APPLICATION NOTE 3479

# DS2154 – Migrating from Revision A2 to D1

*Abstract: This application note describes the procedures for replacing the A2 revision of the DS2154 with the D1 revision of the DS2154. The D1 revision of the DS2154 is a drop-in replacement for the A2 revision of the DS2154. However, it is possible that the user may experience a timing-related issue while replacing the parts. This application note will describe what to do to correct this problem.*

Figure 4. Transmit-side timing between TSYNC and TCLK taken from an oscilloscope.

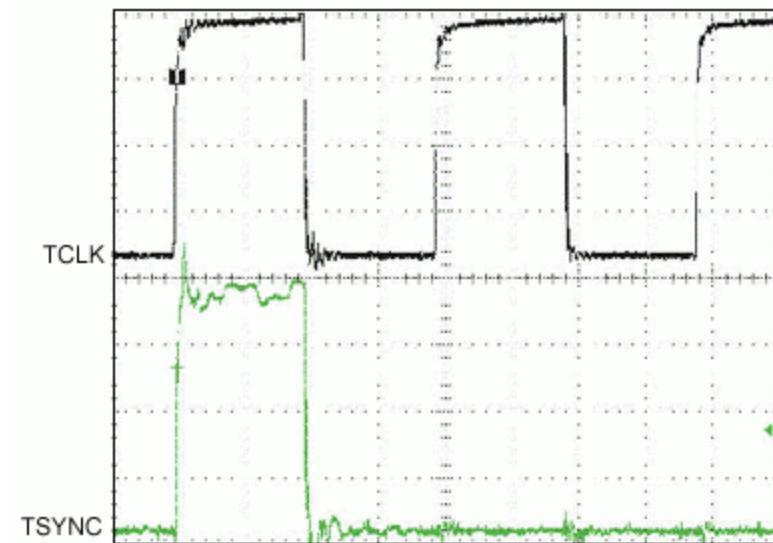
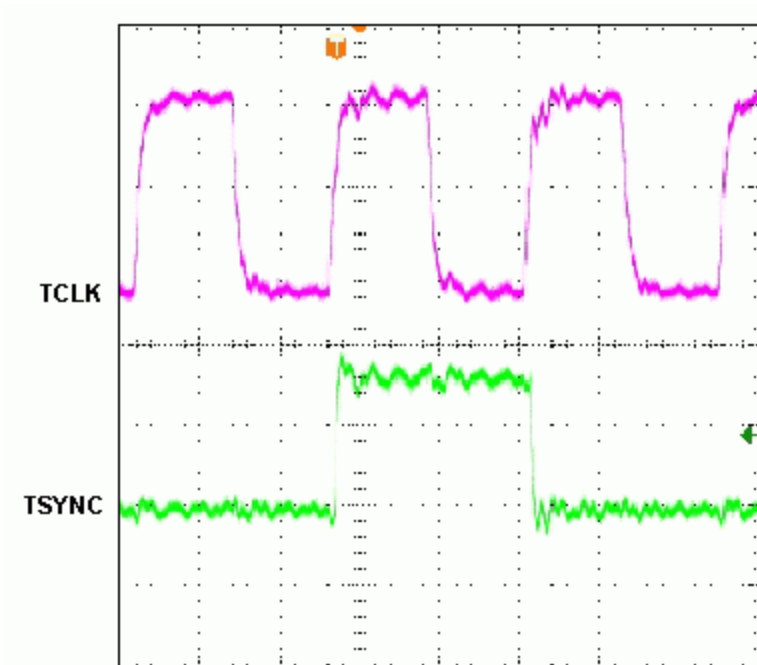
In the DS2154 D1 revision, when TSYNC is configured as an input by setting TCR1.0 = 0 (TSIO = 0), the E1 SYNC signal sometimes does not synchronize correctly with the MSB of time slot 0 (TS0).

**Figure 4** is the scope image of a possible valid timing diagram between TSYNC and TCLK for the DS2154 A2 revision. However, this is not valid for the DS2154 D1 revision.

Figure 4 shows the falling edge of TCLK and TSYNC as being nearly simultaneous. In the D1 revision, the incoming TSYNC is sampled at the falling edge of TCLK. In order to get the correct sampling, the user needs to add 25ns or more delay onto TSYNC. The user can also make the clock pulse of TSYNC wider. This way, the user can solve the sampling problem. The A2 revision of the DS2154 has a rising edge detector to aid in aligning TSYNC with TS0. The D1 revision of the DS2154 simply samples TSYNC with the falling edge of TCLK. **Figure 5** shows the timing diagram between TCLK and TSYNC after making the TSYNC pulse wider.

When replacing the A2 revision of the DS2154 with the D1 revision, most applications will never experience this timing issue. However, if the application experiences this problem, it is recommended to increase the TSYNC delay by 25ns or to widen the TSYNC pulse. For further questions about the operation of the DS2154, please contact the Maxim Telecommunications Applications support team through email: [telecom.support@maximintegrated.com](mailto:telecom.support@maximintegrated.com), or phone: 972-371-6555.
